**ON-SITE SEWAGE DISPOSAL SYSTEM
 HOWARD COUNTY HEALTH DEPARTMENT
 BUREAU OF ENVIRONMENTAL HEALTH
 3525-H ELLICOTT MILLS DRIVE, ELLICOTT CITY, MD 21043
 04-367758**

Fogles Septic Clean, Inc IS PERMITTED TO INSTALL ALTER
 ADDRESS: 580 Obrecht Road, Sykesville PHONE NUMBER: 410-795-5670
 SUBDIVISION: Waterford Farms LOT NUMBER: 11
 ADDRESS: 3175 Lorenzo Lane PROPERTY OWNER: Toll MD 2
 SEPTIC TANK CAPACITY (GALLONS): 1500 OUTLET BAFFLE FILTER REQUIRED
 PUMP CHAMBER CAPACITY (GALLONS): 1500 COMPARTMENTED TANK REQUIRED
 NUMBER OF BEDROOMS: 5
 SQUARE FEET PER BEDROOM: 180
 LINEAR FEET OF TRENCH REQUIRED: 250 HOUSE SERVED BY PUBLIC WATER

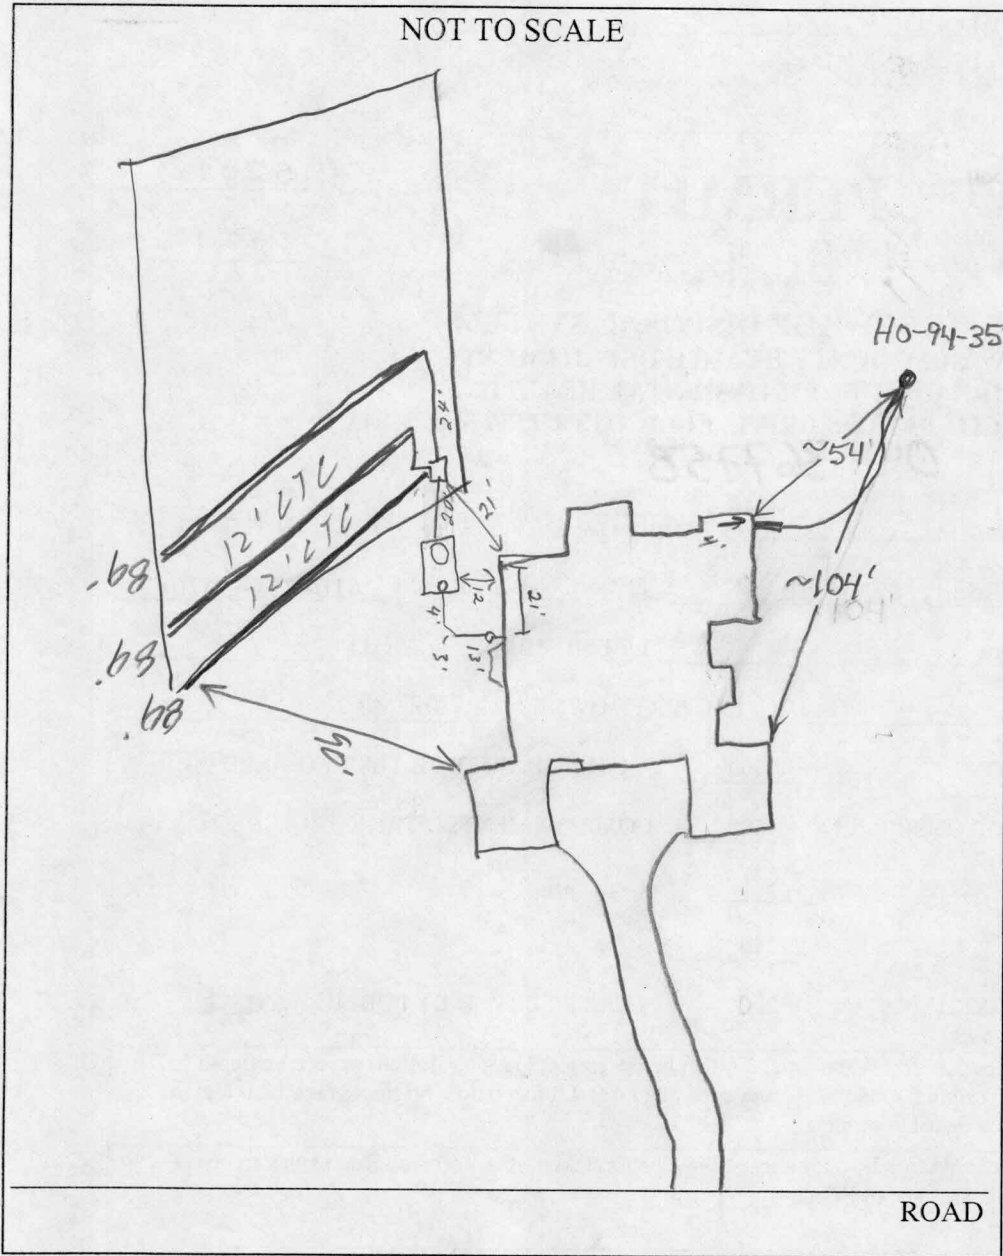
PRE-CONSTRUCTION 8/27/04 - SRA not staked, contour does not look accurate. Have stake & call for another layout (SO)

INSTALLATION 8/30/04 Easement not staked. No work done. (BB)

8/31/04 - SRA staked, OK to install (3) 80' trenches (SO)

9/1/04 - Tank set OK to cover (SO)

9/2/04 - All work complete. OK to cover (SO)
